**Re: Premises – 19 Joseph Street, AVALON NSW 2107  
BCA Compliance Inspection & Commentary**

The purpose of this report is to identify the requirements of the BCA for the free-standing carport and dwelling additions. This report is a high-level document providing a commentary on any major areas of non-compliance with the BCA and presenting suitable strategies to ensure BCA compliance.

We are in receipt of a copy of architectural plans prepared by Blue Sky Building Designs, dated 27.05.2019, Project Number 2019030, Rev 1, Drawings Numbered A101 – A104 including – Site Plan, Ground Floor Plan, Elevations, Carport and Notification Plan

THIS IS THE SKETCH REFERRED TO IN MY  
 REPORT WITH REFERENCE NO. 3226 AND  
 DATED 20 MAY, 2019.

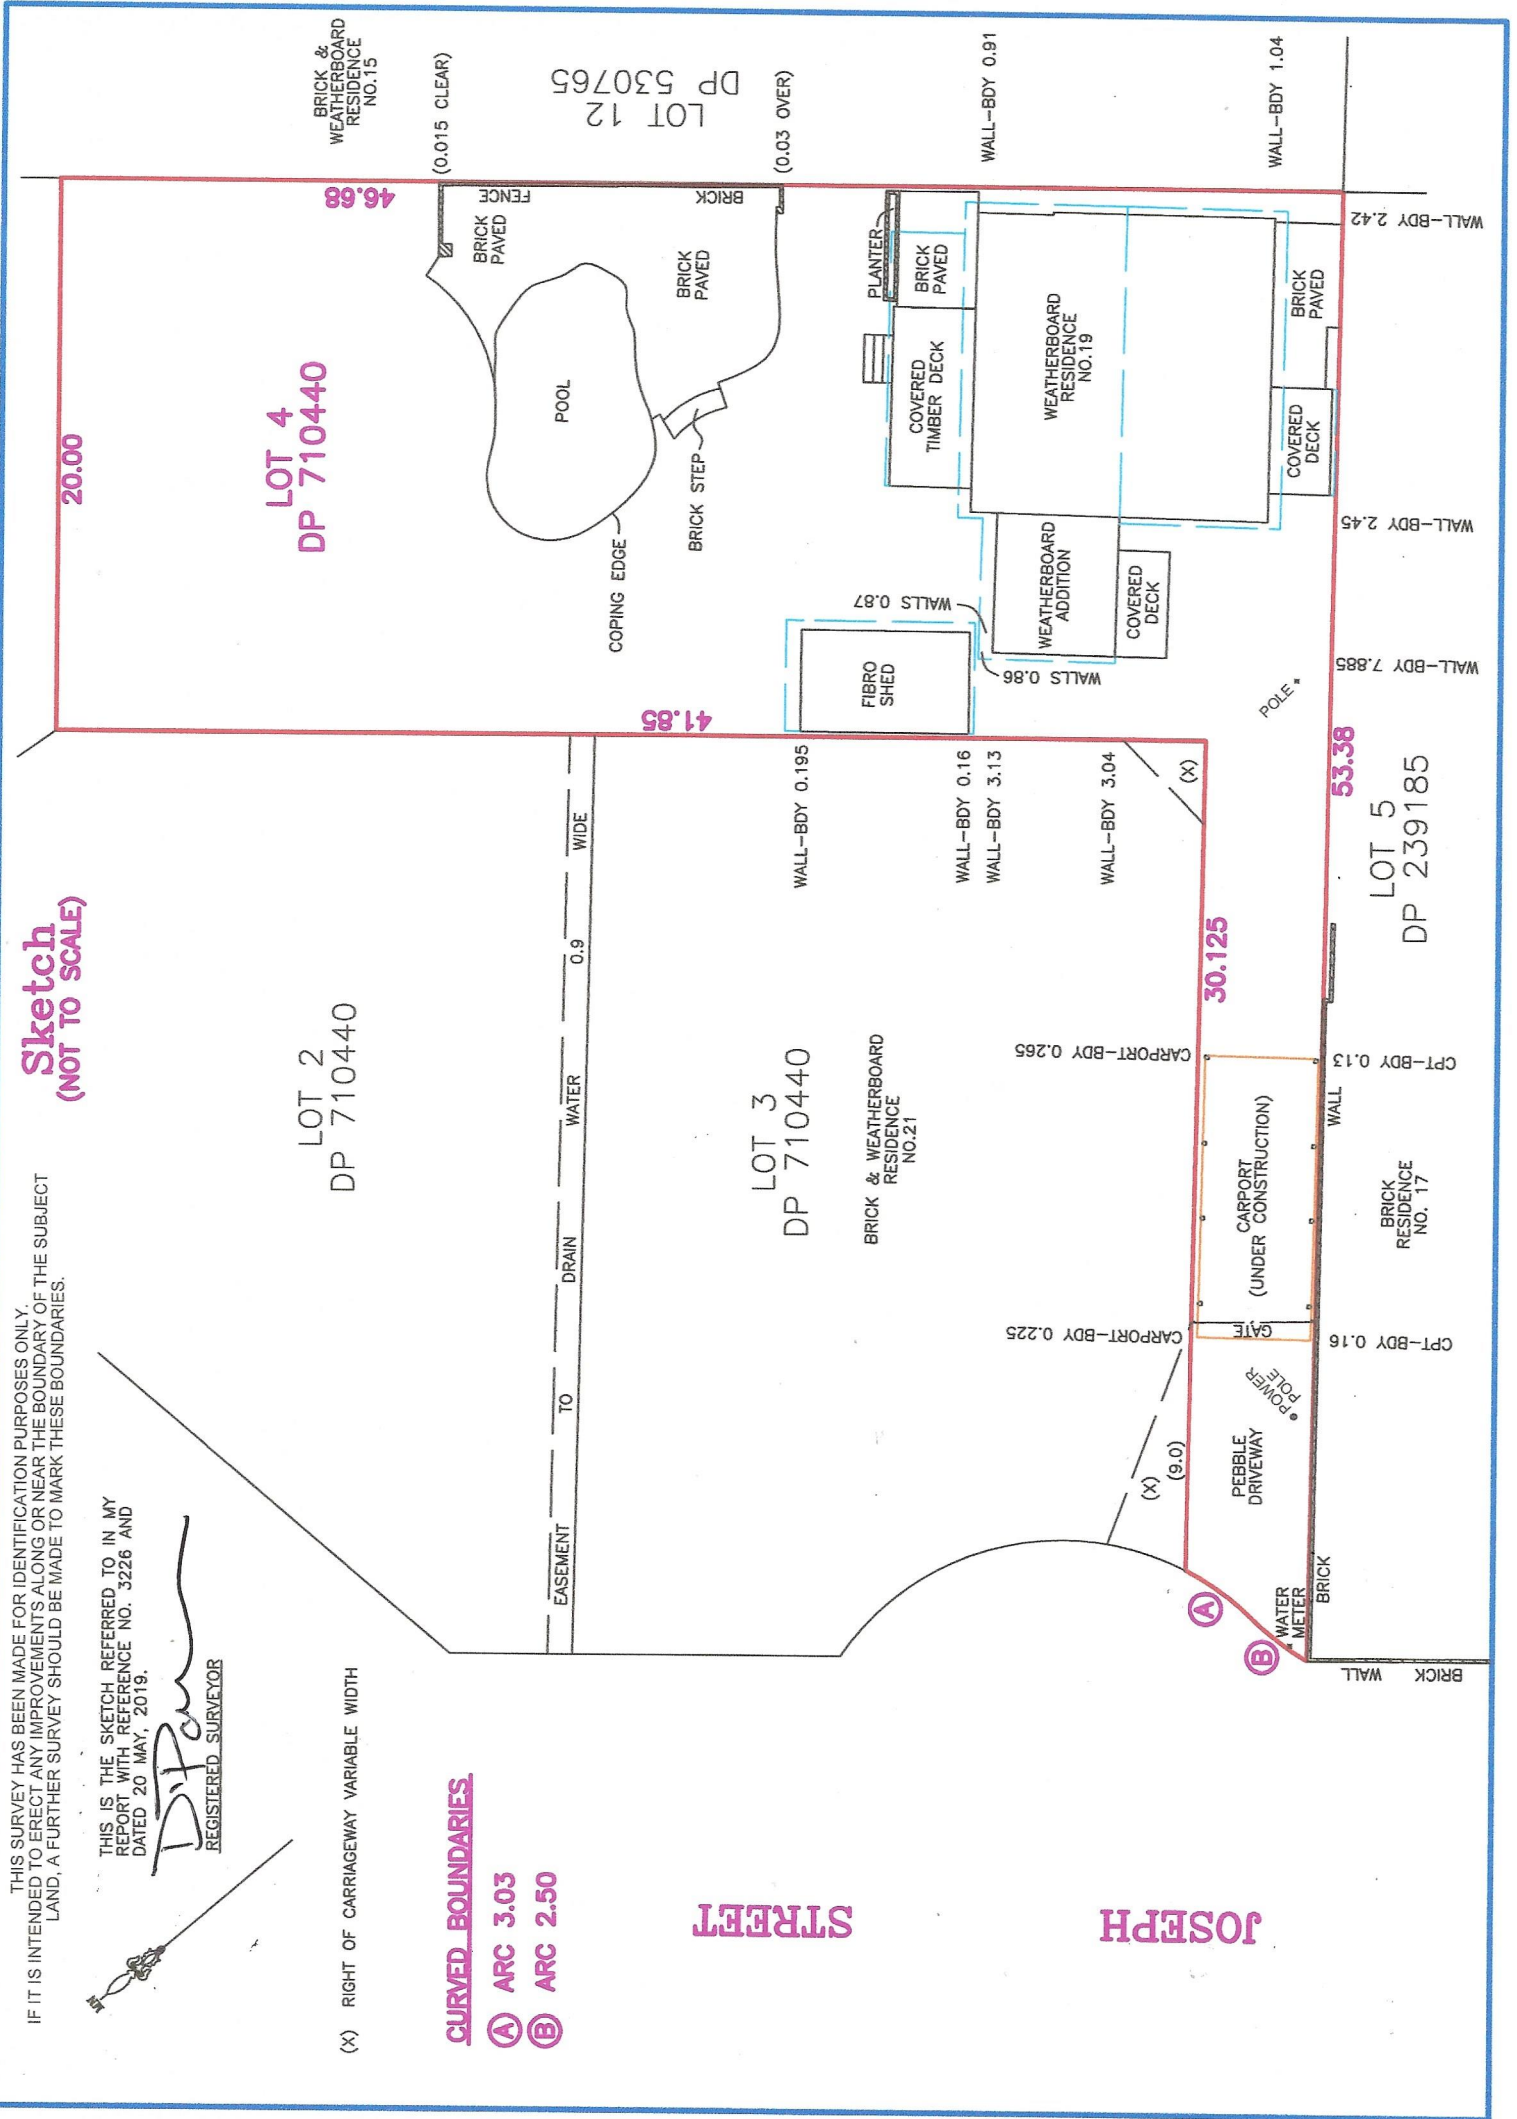
The dwelling is separated from the rear side shed by a distance of 870mm – see attached a copy of the survey report prepared by David Parsons.

To comply with the terms of the BCA, it is recommended that the rear facing wall of the shed (to the dwelling and the additions) be upgraded to achieve a fire resistance level (FRL) of not less 60/60/60 where the separation between the dwelling and the shed is less than 900mm.

The carport is setback from the existing dwelling (on the same allotment) by more than 1.8m – see attached, a copy of the survey report. No additional fire safety upgrade works are required for BCA compliance purposes.

To achieve the necessary FRL, a possible solution would be to over clad the external cladding of the shed with a product such as Hebel Power Panel.

That the northern side wall of the shed (facing the dwelling and the studio additions) is upgraded to achieve a fire resistance level of 60/60/60. It is suggested that a product like Hebel Power Panel be used to achieve this requirement.
